Dolby Laboratories Inc

Field Bulletin 223

Models CP500 and DA20

Slow switching to Dolby Digital sound

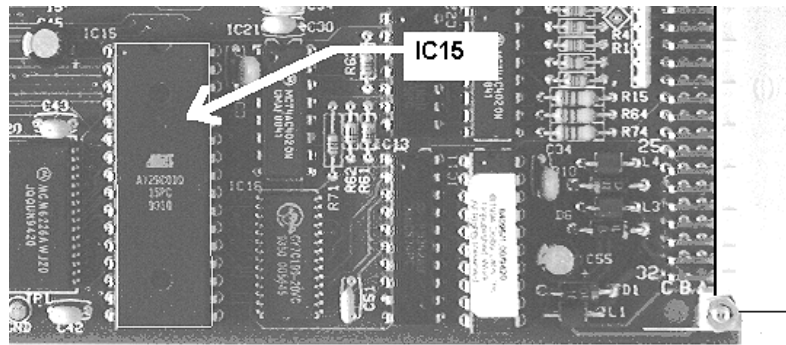
2. Replace IC15 on the Cat. No. 673(A)

Install a new IC15 ROM which is obtainable from Dolby Laboratories:

Part Number 84092 for Cat. No. 673, or
Part Number 84147 for Cat. No. 673A.

1. Switch off the cinema processor and remove the Cat. 673(A) card.
2. Locate IC15. Note the orientation of the IC.

3. Be sure that your wrist strap is adequately grounded and gently remove IC15 from its socket using an IC extractor tool.
4. Install the new IC15 in the socket. Be sure that no pins are bent and that all pins fit into the socket holes.
5. Reinstall the card in the processor.
